DIVISION OF AIR QUALITY
Bryce C. Bird
Director

Re: Engineer Review:
New I-80 Aggregate Mining Facility
Project Number: N161200001

UTAH DIVISION OF AIR QUALITY ENGINEER REVIEW

Project Number	N161200001
Owner Name	Granite Construction Company
Mailing Address	1000 North Warm Springs Rd. Salt Lake City, UT, 84116
Source Name	Granite Construction Company- I-80 South Quarry
Source Location	Off Exit 132, Ranch Exit of Interstate I-80 East of Salt Lake City Salt Lake County, UT
UTM Projection	437,048 m Easting, 4,509,436 m Northing
UTM Datum	NAD83
UTM Zone	UTM Zone 12
SIC Code	1442 (Construction Sand & Gravel)
Source Contact	Quinten Bingham
Phone Number	(801) 526-6050
Email	quin.bingham@gcinc.com
Project Engineer	John Persons, Engineer
Phone Number	(385) 306-6503
Email	jpgersons@utah.gov
Notice of Intent (NOI) Submitted	September 7, 2022
Date of Accepted Application	September 29, 2022

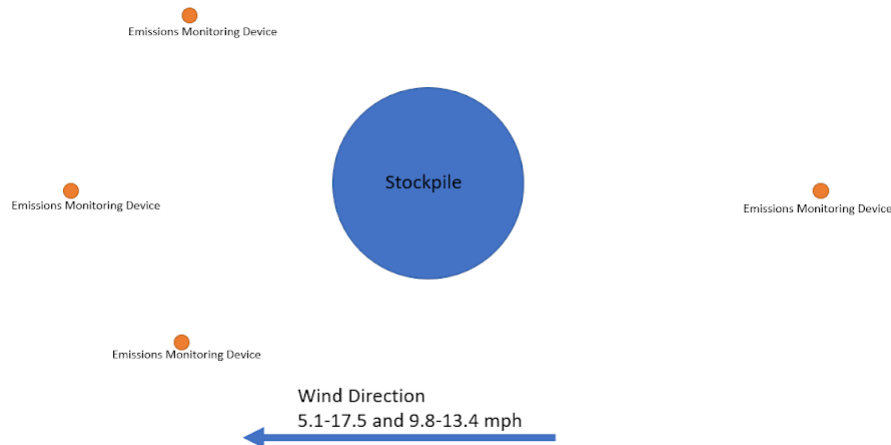
In our current submitted model, we model wind erosion based on (1) disturbed area using the EF in 5th Edition AP-42, Table 11.9-4 (see attached screenshot) and (2) stockpile wind erosion is included in the material handling equation of 5th Edition AP-42 Section 13.2.4.3 (see attached screenshot). However, John has instructed that we use the 4th Edition AP-42 Table 8.19.1-1 "inactive stockpile" EF.

On previous projects we were directed by DAQ to not use the 4th edition of AP-42; specifically, Table 8.19.1-1 (attached screenshot). Historically, we have used the 4th edition AP-42, Table 8.19.1-1 EF and were told not to use the 4th edition and to use EFs from the 5th edition only. Specifically, we were instructed to use values in Table 11.9-4 (Western Coal Mines) (see attached screenshot).

After conversing with Eq and Alan, the DAQ has decided that Granite will have to add emissions from wind erosion from its storage piles. It is the DAQ's understanding that the equations used to calculate loading/unloading emissions from storage piles (AP-42 13.2.4) do not include emissions from wind erosion. DAQ recommends that granite use the emissions factor for active storage piles listed in AP-42 Forth edition Table 8-19.1.1 (6.3 lb/acre/day PM10). DAQ has used this emissions factor as standard practice for estimating wind erosion from storage piles at aggregate facilities.
